HISTORIC LANDMARK COMMISSION
PERMITS IN NATIONAL REGISTER HISTORIC DISTRICTS
DECEMBER 13, 2023
HR-2023-122515; GF-2023-130947
OLD WEST AUSTIN
1621 WEST 14TH STREET

PROPOSAL

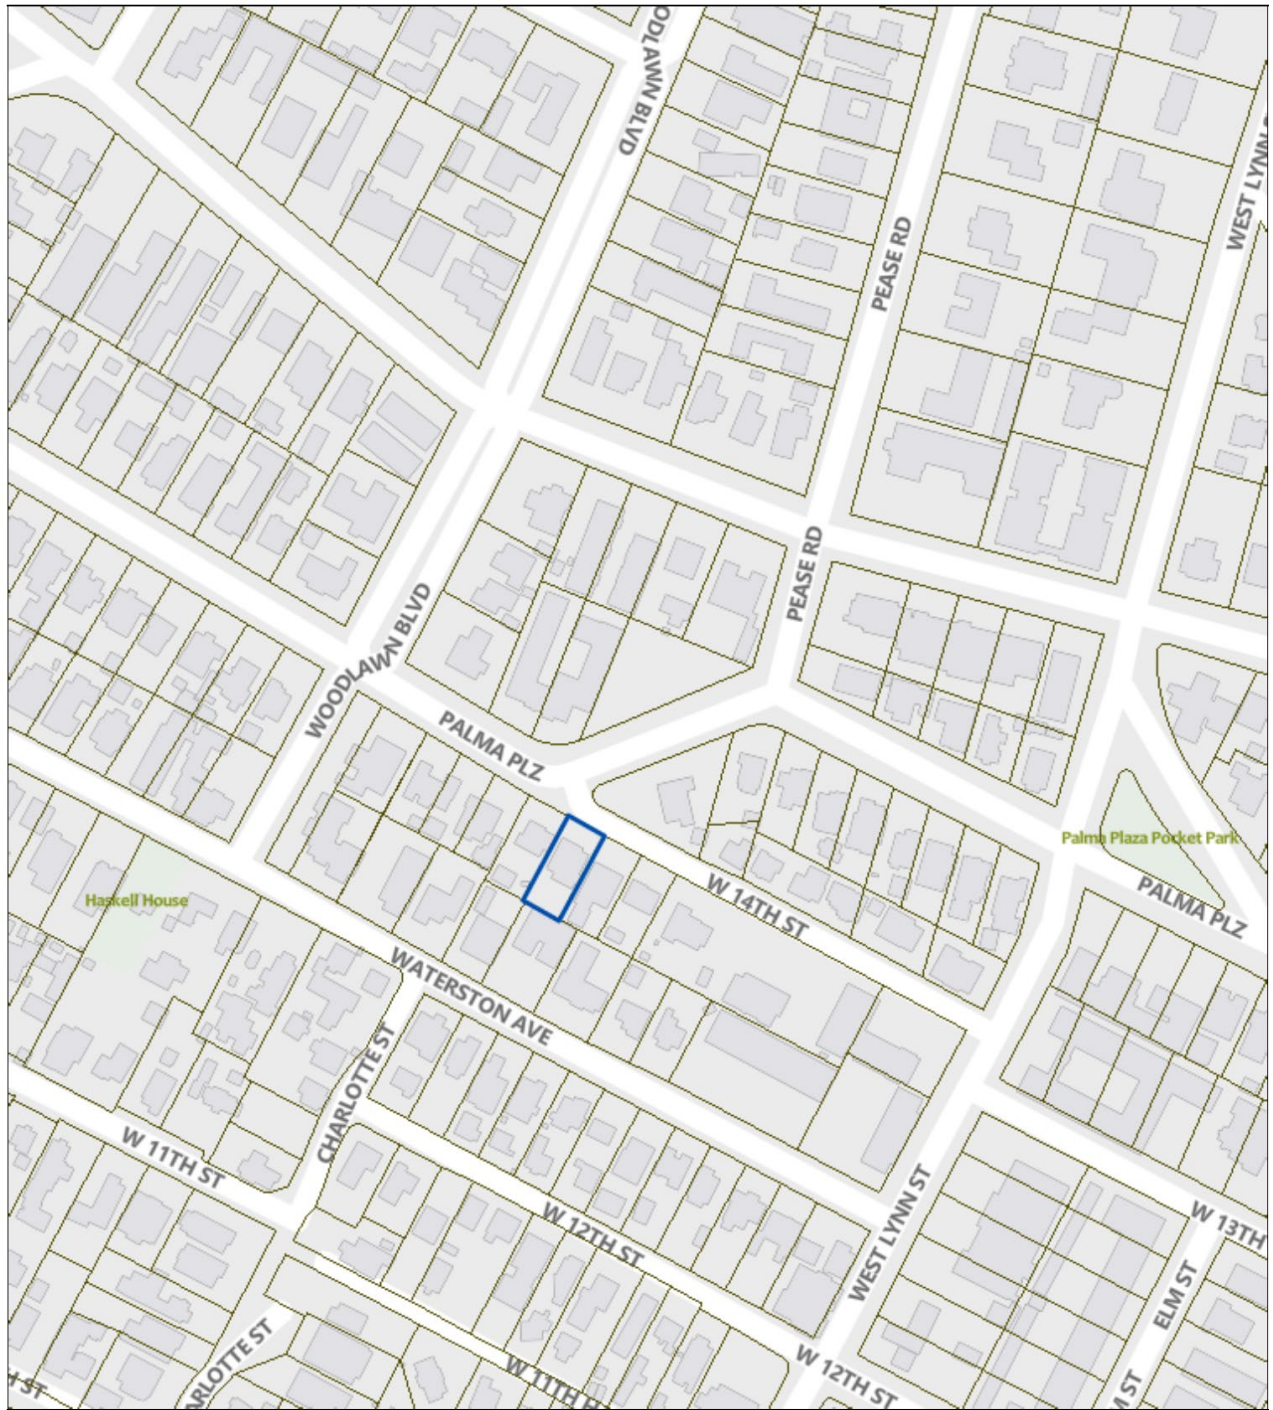
The proposed project removes all intact historic material from the house's exterior and changes its form entirely.

The proposed roof reconfiguration is not compatible with the district or the existing house.

The proposed stucco paneling does not reflect the design of nearby contributing buildings in the district.

The proposed project removes and replaces all windows and doors and does not maintain existing openings. The new fenestration is not compatible with the district.

The proposed project does not retain the existing porch. The proposed second-floor balcony and staircase is not compatible with the district.

The project does not meet the applicable standards.

Comment on plans.
